IDEA PUBLIC SCHOOLS – Mid Valley Building Envelope

ADDENDUM NO. 3

(ATTACHED: RFI from Argio Roofing with GMS Response. Responses included in the following addendum). Total Sheets = 23

BUILDING A
01 ROOF PLAN
SCALE: 3/32" = 1'-0"

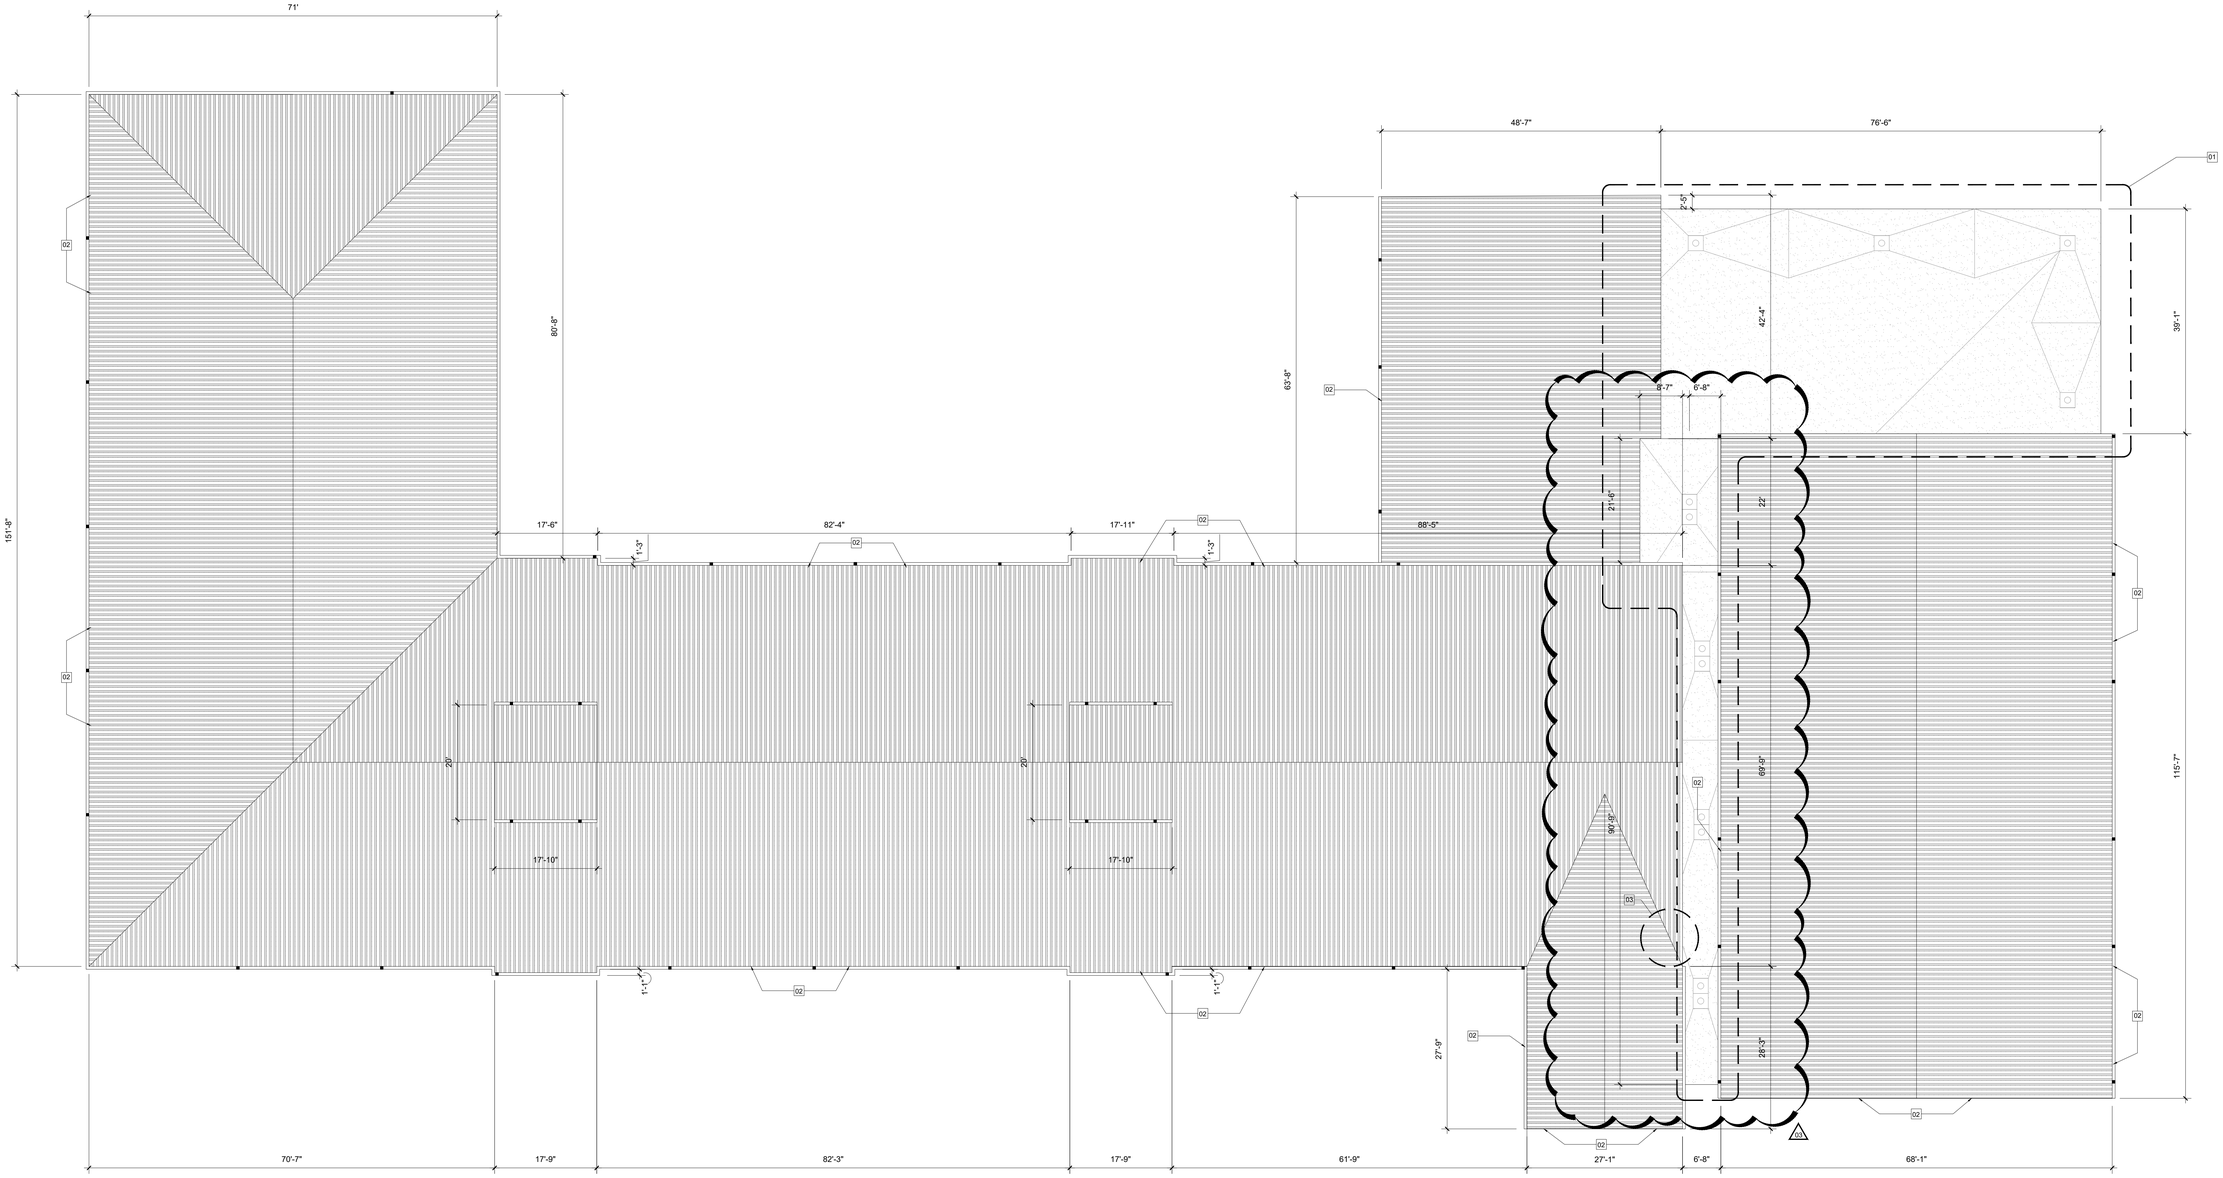
- Roof tiles damaged during testing shall be replaced as required, refer to updated general note on A2.01.
- Clarification: The roof between the two metal roofs shall be replaced (tear off to deck). Refer to updated sheet A2.01

- Clarification: Location of wall hole clarified. Extend roof membrane over hole as per parapet roof membrane assembly. Refer to updated sheet A2.01
- Clarification: Provide walkway system to and around mechanical equipment roof hatches and roof access ladders on bitumen roof. Refer to A2.01 scope notes.

1. REMOVE AND REPLACE ROOFING IN AFFECTED AREAS AS NOTED
2. REFER TO SHEET A3.01 FOR DETAILS
3. PURGE DRAIN LINES FROM ROOF LEVEL TO DISCHARGE POINTS.
4. PERFORM WATER TEST AT ALL ROOF DRAINS.
5. STRIP ROOFING MEMBRANE TO RECOVER BOARD.
6. INSTALL NEW MODIFIED BITUMEN ROOFING SYSTEM.
7. INSTALL NEW CAP FASCIA AND ACCESSORIES.
8. PROVIDE CONCRETE SPLASH BLOCK AT EXTERIOR DOWNSPOUTS.
9. ADD NEW ROOF DRAIN STRAINERS WHERE MISSING
10. REMOVE AND REPLACE FASTENERS AT ROOF
11. RESEAL LAPPED SHEET METAL AT RIDGES AND VALLEYS
12. REPLACE BOOT FLASHING ON VENT STACKS, AND SEAL NEW FASTENERS
13. PROVIDE WALKWAY SYSTEM TO AND AROUND MECHANICAL EQUIPMENT, ROOF ACCESS LADDERS AND ROOF HATCHES ON BITUMEN ROOFS

BUILDING A
01 SOUTH ELEVATION
SCALE: 1/8" = 1'-0"

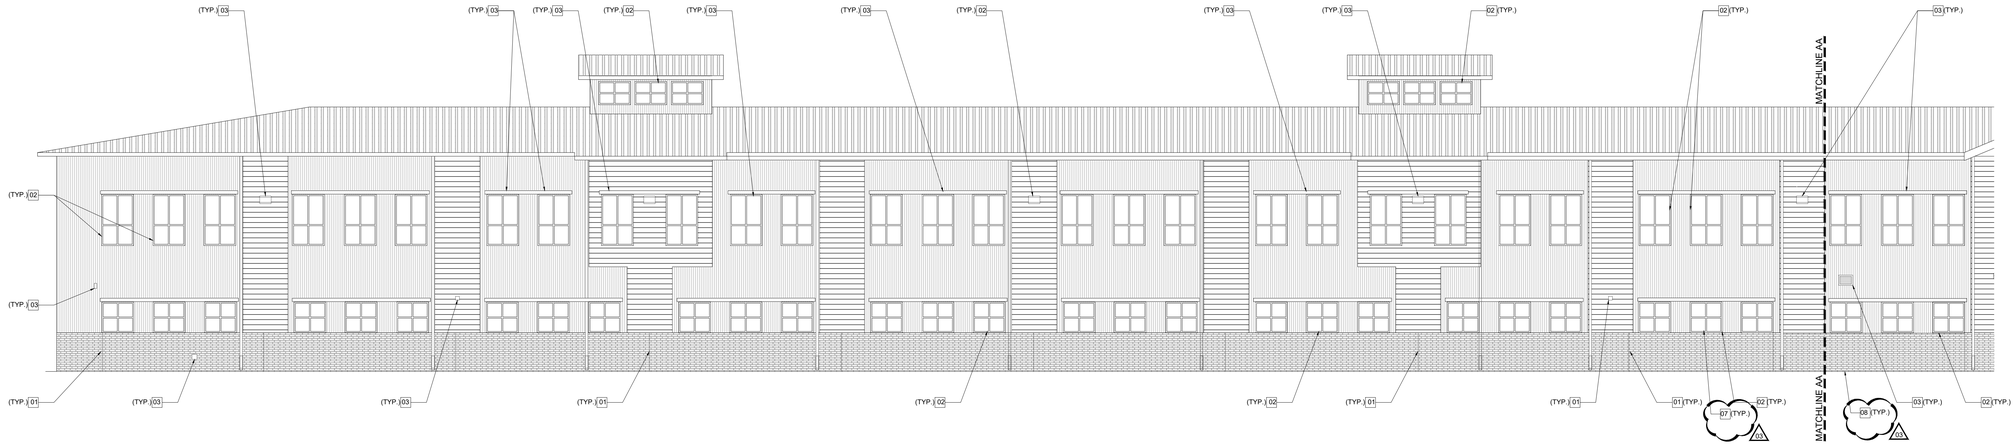
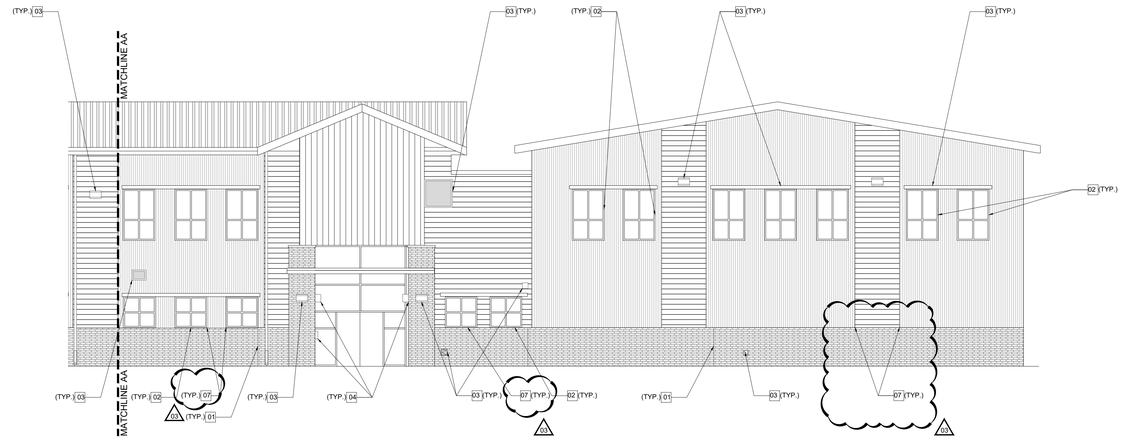
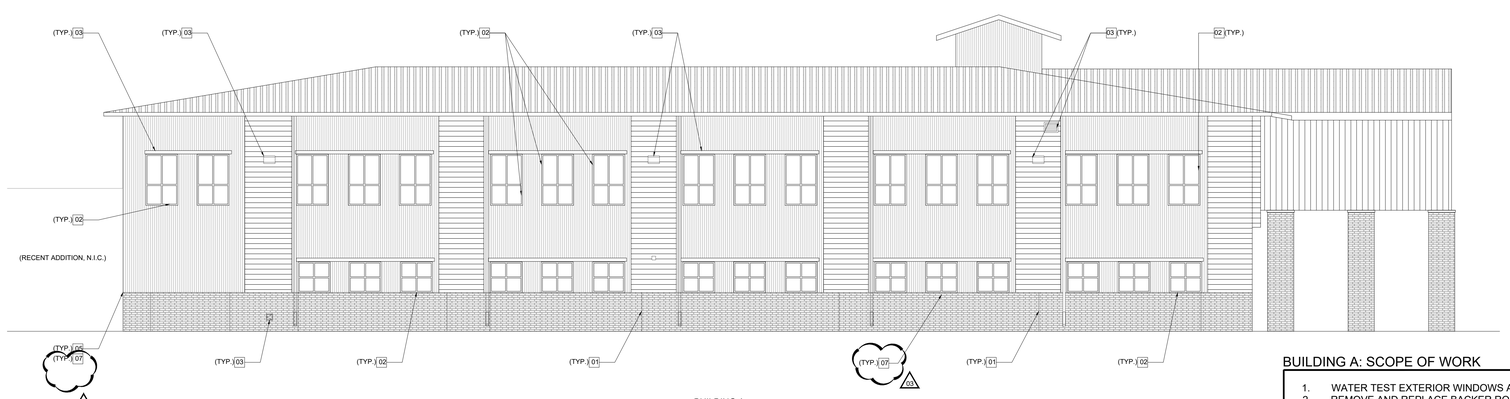
- Metal panels to match existing. Contractor to provide comparative sample so that replacement matches gauge and color of existing.
- Add backer rod and sealant between lapped flashing over brick wainscot, typical. See updated keynote on elevations. Refer to updated keynote on elevations.

- Replace fasteners on all ridges/valleys and provide new sealant between existing laps. Refer to updated notes on elevations.
- Re-grade at brick wainscot where grade covers up weep holes. See updated note and tags on elevations A5.01-A5.02.

01	REPLACE CONTROL/EXPANSION/MATERIAL CHANGE JOINTS WITH NEW SEALANT, TYP. REFER TO 01/A4.01
02	REPLACE ALL SEALANT & BACKER RODS @ DOORS/WINDOWS/EQUIPMENT CONTROL JOINTS, TYP. REFER TO SHEET A4.02
03	RE-SEAL ALL WALL EXTERIOR PENETRATIONS, TYP. INCLUDING AT ATTACHMENT OF OVERHANGS TO WALL
04	RE-SEAL AT ALL FIXURES AND WALL PENETRATIONS INSIDE COVE OR UNDER SOFFIT
05	REPAIR METAL FLASHING AT MASONRY, REFER TO 03/A4.01
06	REMOVE DAMAGED PANELS AND REPLACE WITH NEW TO MATCH EXISTING, REFER TO 02/A4.01
07	ADD SEALANT AND MISSING FASTENERS TO METAL FLASHING LAPS AT MASONRY
08	CLEAN WEEPHOLES AND REGRADE TO ALLOW FOR 6" CLEAR BETWEEN WEEP HOLE AND GRADE

BUILDING A
01 NORTH ELEVATION
SCALE: 1/8" = 1'-0"

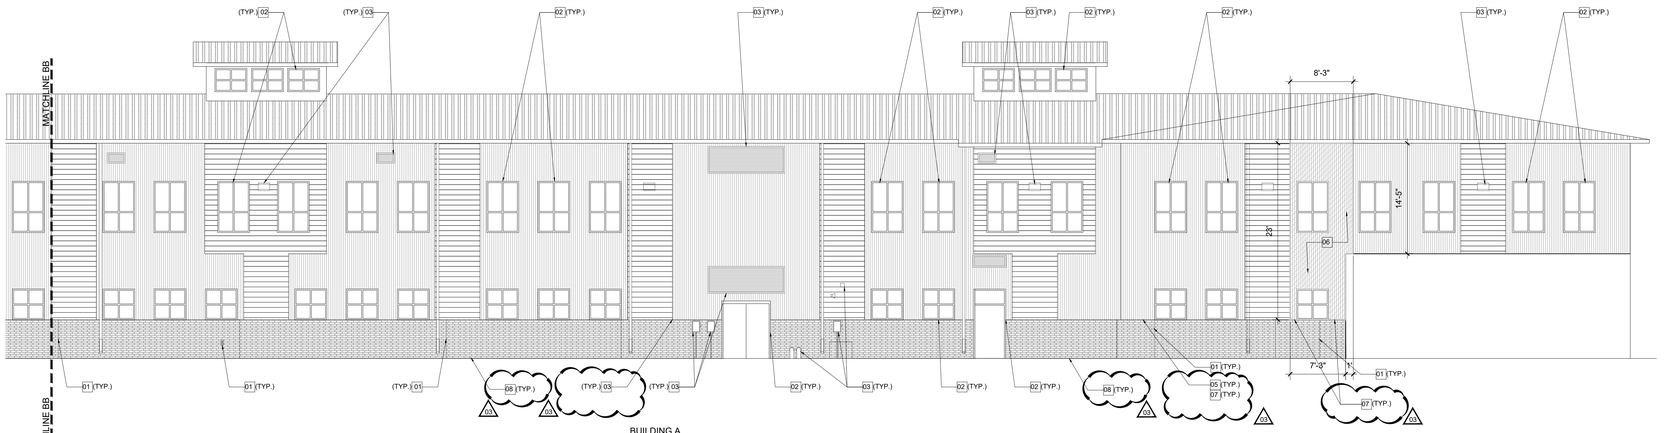
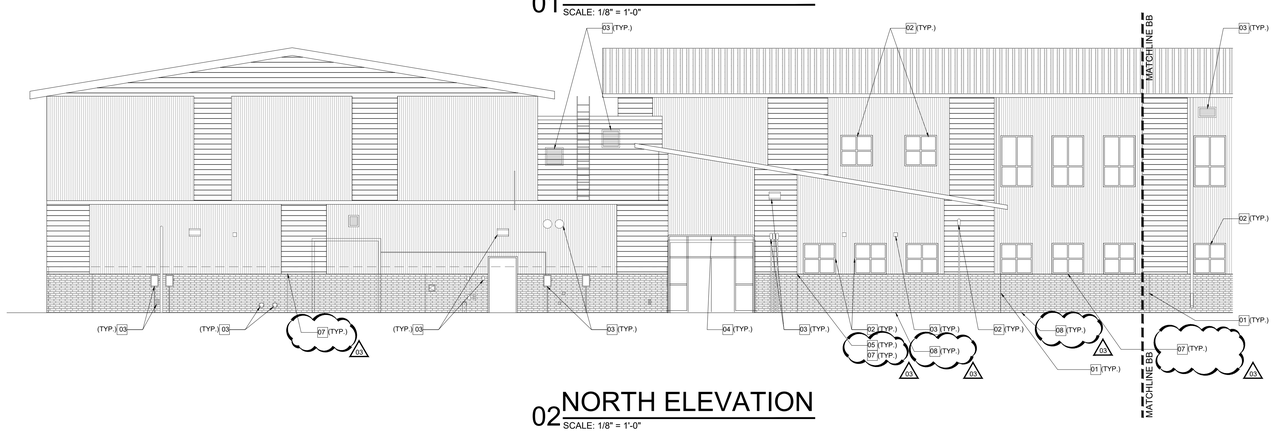
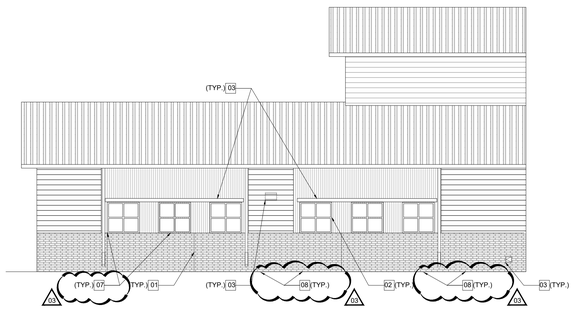
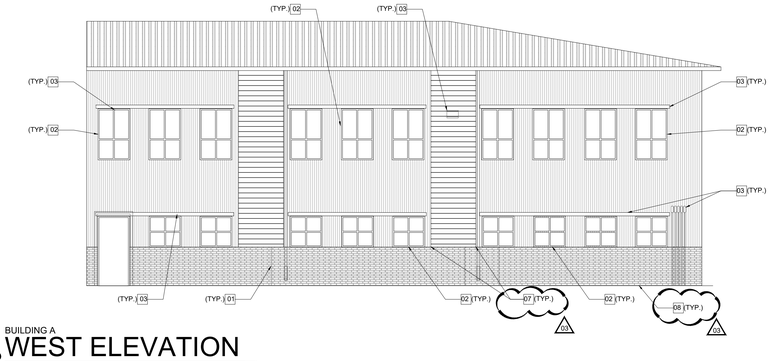
3. Page 5.02, 01 north elevation, just below the area where the wall panels are being changed, there is a flower bed with rocks, the brick whip holes are covered with soil and rocks at the flower bed, there is there no grading on this site, will it be handled through contingency funds once the areas are identified? Grade to uncover weeps throughout project, typical.
4. Testing the roof drains may require removing some ceiling tiles, do we consider replacing tiles at all or will that be done by owner.

01	REPLACE CONTROL/EXPANSION/MATERIAL CHANGE JOINTS WITH NEW SEALANT, TYP. REFER TO 01/A4.01
02	REPLACE ALL SEALANT & BACKER RODS @ DOORS/WINDOWS/EQUIPMENT CONTROL JOINTS, TYP. REFER TO SHEET A4.0
03	RE-SEAL ALL WALL EXTERIOR PENETRATIONS, TYP. INCLUDING AT ATTACHMENT OF OVERHANGS TO WALL
04	RE-SEAL AT ALL FIXURES AND WALL PENETRATIONS INSIDE COVE OR UNDER SOFFIT
05	REPAIR METAL FLASHING AT MASONRY, REFER TO 03/A4.01
06	REMOVE DAMAGED PANELS AND REPLACE WITH NEW TO MATCH EXISTING, REFER TO 02/A4.01
07	ADD SEALANT AND MISSING FASTENERS TO METAL FLASHING LAPS AT MASONRY
08	CLEAN WEEPHOLES AND REGRADE TO ALLOW FOR 6" CLEAR BETWEEN WEEP HOLE AND GRADE
